Item Name: Quick Release Basket and Long Cargo Tube Mounting, Fits LH or RH

DART SERVICE INSTRUCTION

**TO AMEND INSTALLATION INSTRUCTIONS D350-607-3 Rev.D,
INSTALLATION INSTRUCTIONS D350-607-4 Rev. C AND
INSTRUCTIONS FOR CONTINUED AIRWORTHINESS ICA-D350-607 REV. 6**

A	NEW ISSUE	AJS	14.05.16
REV.	DESCRIPTION	BY	DATE
DESIGN	AJS	DART AEROSPACE LTD HAWKESBURY, ONTARIO, CANADA	
DRAWN	AJS		
CHECKED		DRAWING NO.	REV. A
MFG. APPR.	N/A	DSI 9699	SHEET 1 OF 2
APPROVED		TITLE	SCALE
DE APPR.		LUG REPLACEMENT	NTS
DATE	14.05.16	COPYRIGHT © 2014 BY DART AEROSPACE LTD THIS DOCUMENT IS PRIVATE AND CONFIDENTIAL AND IS SUPPLIED ON THE EXPRESS CONDITION THAT IT IS NOT TO BE USED FOR ANY PURPOSE OR COPIED OR COMMUNICATED TO ANY OTHER PERSON WITHOUT WRITTEN PERMISSION FROM DART AEROSPACE LTD.

FIGURE 1: INSTALLATION OF D4775-041 FWD STRUT

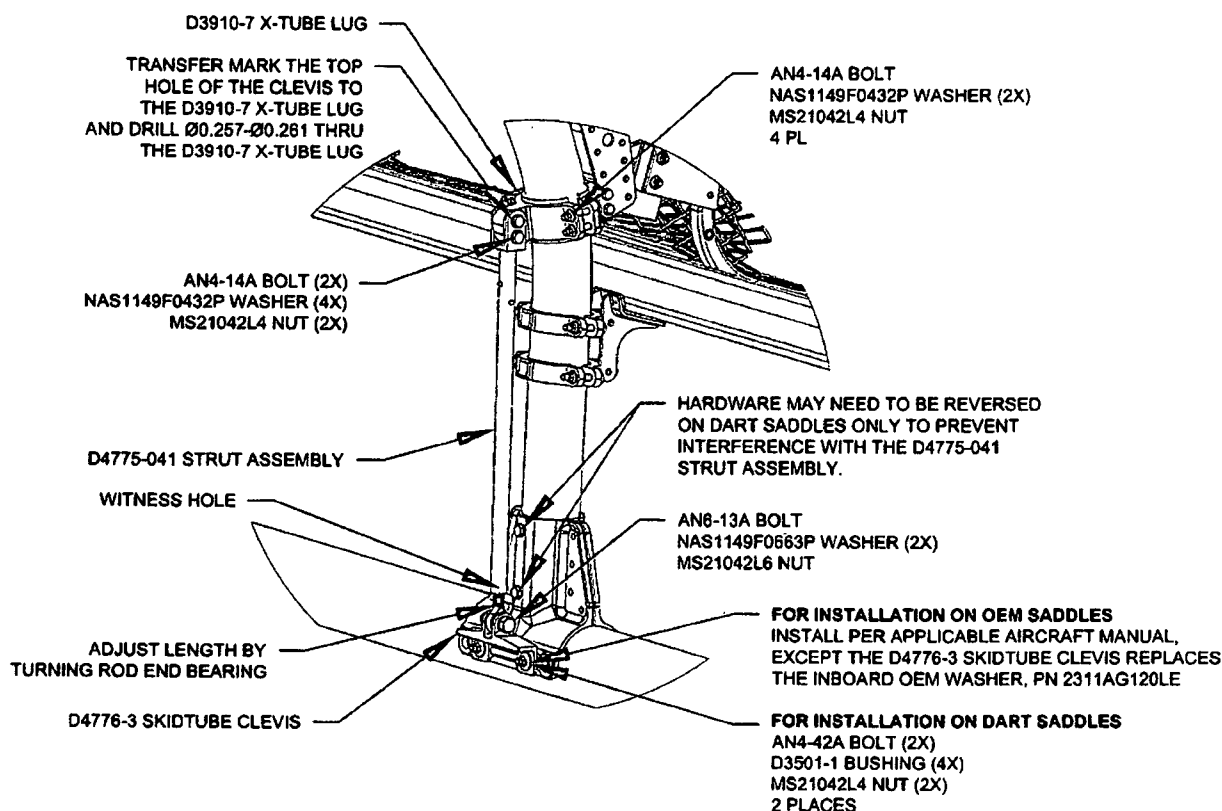
- 3.1 Substitute the Forward Lower D3910-5 X-Tube Lug with the D3910-7 X-Tube Lug as shown in Figure 1.
- 3.2 Install the forward D4775-041 Strut Assembly. Transfer mark from the upper hole on the clevis of the D4775-041 Strut Assembly to the D3910-7 X-tube Lug and drill thru the lug $\varnothing 0.257 - \varnothing 0.261$ as shown in Figure 1. Touch up chemical conversion coating per MIL-DTL-5541. Check the witness holes located at the bottom end of the D4775-041 Strut Assemblies to ensure that the thread from the rod end extends past the witness hole.
Torque MS21042L4/-4 nuts to 50-70 in-lbs (5.7-7.9 N-m). Torque MS21042L6/-6 nuts to 160-190 in-lbs (18.1-21.5 N-m).
- 3.3 Complete the installation in accordance with Installation Instructions D350-607-3 Rev. D or D350-607-4 Rev. C.
